**ADDENDUM NUMBER:** Three (3)  
**DATE:** February 3, 2026  
**PROJECT:** Interior Renovations for Montgomery County Assessor of Property  
**DESIGNER:** DOUGLAS A. JONES, ARCHITECT  
 MONTGOMERY COUNTY ENGINEERING  
**BID OPENING:** February 10, 2026, at 2:00 P.M.

**TO PLANHOLDERS:** This addendum is issued to modify the original Project Manual and Project Drawings dated January 14, 2026, and is hereby made part of the contract documents. Acknowledge receipt of this Addendum in the space provided on the Bid Form. Failure to do so may subject the Bidder to disqualification.

CEILING DEMOLITION PLAN  
INTERIOR RENOVATIONS FOR  
MONTGOMERY COUNTY ASSESSOR OF PROPERTY  
350 PAGEANT LANE, SUITES 401 & 402  
CLARKSVILLE, TENNESSEE

**D1.3**

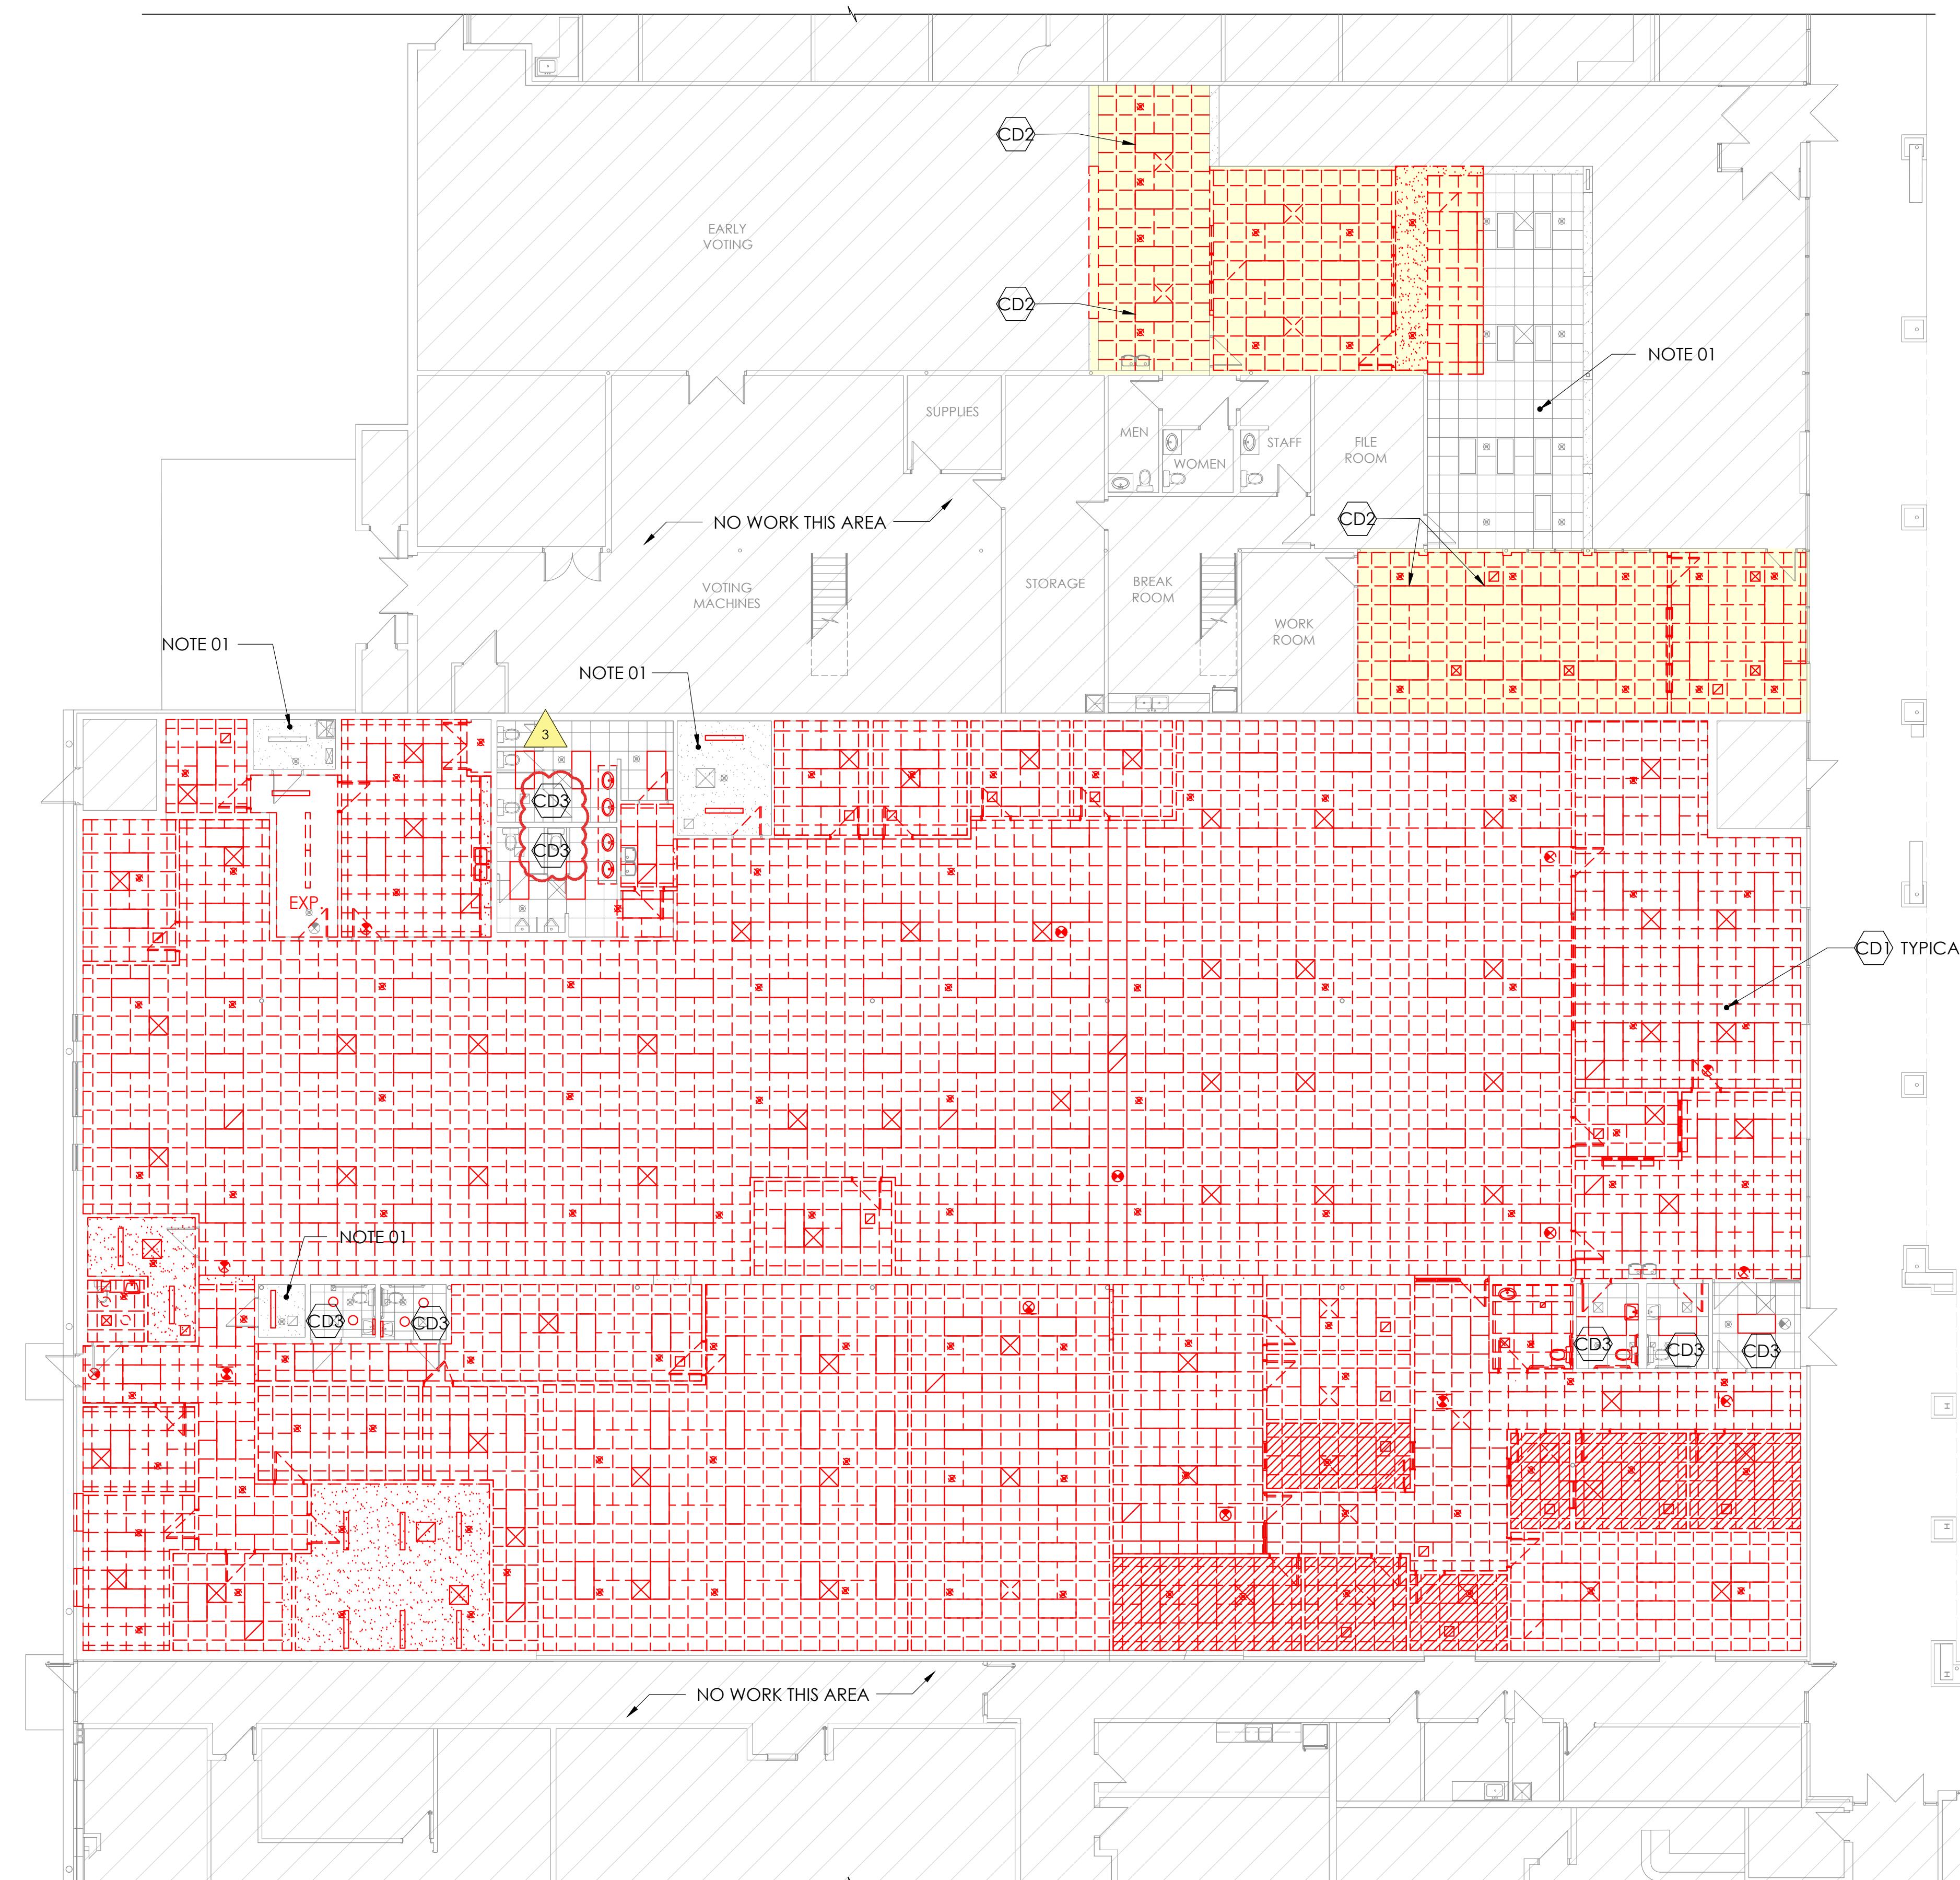
SHEET D1.3 CEILING DEMOLITION PLAN; Delete Sheet D1.3 dated 01/14/2026 and Substitute Therefor Sheet D1.3 Dated 2/3/2026 attached hereto.

Clarification: Ceiling Demolition Tags in Women A128 & Men A129 have been changed from CD1 to CD3.

**Q:** Ceiling Demo Plan Shows Demolition Notes CD! For A128 and A129. It states removing the ceiling in its entirety d1.3) Reflected Ceiling plan shows existing grid to remain and provide new ceiling tile A6.1) Just looking for clarification on this so we can bid properly.

**A:** The CD1 tags in Women A128 & Men A129 on D1.3 are an error. They have been changed to CD3. Refer to item 03 above.
